JACKSON COUNTY

Health and Human Services
Environmental Public Health

March 21, 2019

Joanna Davis
Applegate River Lodge, PWS #4191557
15100 Hwy 238
Applegate, OR 97530

Wellhead View #1

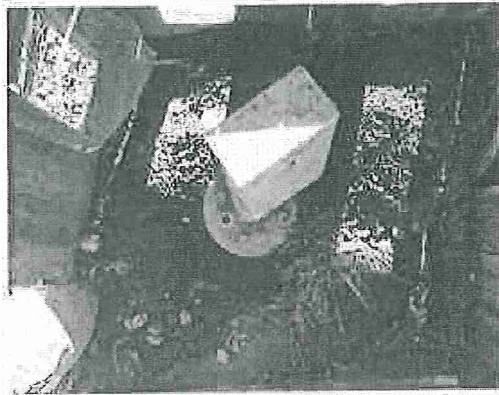
I was able to identify a possible pathway of contamination at the wellhead. These findings included soil mounded around the well head. The well house was open to weather, animals and birds which could allow contamination to enter the well through the upturned screened vent (see photos below).

- The mounded soil around the wellhead should be removed and the ground surface shall be graded so that drainage is away from the well. (see OAR 333-061-0050 (2)(a)(K)(ix)).
- The water system should retrofit the wellhead with a pitless adapter or a reinforced concrete slab shall be poured around the well casing so that drainage is away from the well (see OAR 333-061-0050 (2)(a)(K)(viii & xiii)).

- The casing vent shall be fitted with a screened return bend (see OAR 333-061-0050 (2)(a)(K)(iii)).

The top of the well casing shall extend 12 inches above the concrete slab see OAR 333-061-0050 (2)(a)(K)(x)).

Well House Condition

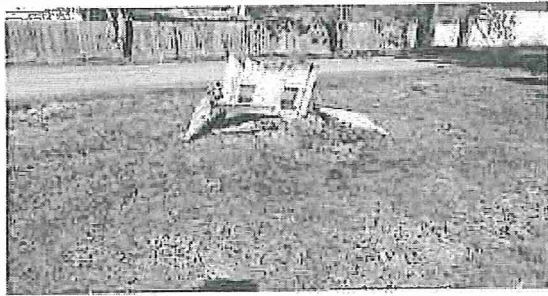
- Operator shall install a protective and secured building around the wellhead.
- Provisions shall be made for protecting pump controls and other above-ground appurtenances at the well head.

Where a wellhouse is installed for this purpose, it shall meet applicable building codes and shall be insulated, heated and provided with lights, except that where the wellhouse consists of a small removable box-like structure the requirement for lights may be waived by the Authority; (see OAR 333-061-0050 (2)(a)(K) (xi)

The wellhouse shall be constructed so that the well pump can be removed. (see OAR 333-061-0050 (2)(a)(K)(xii))
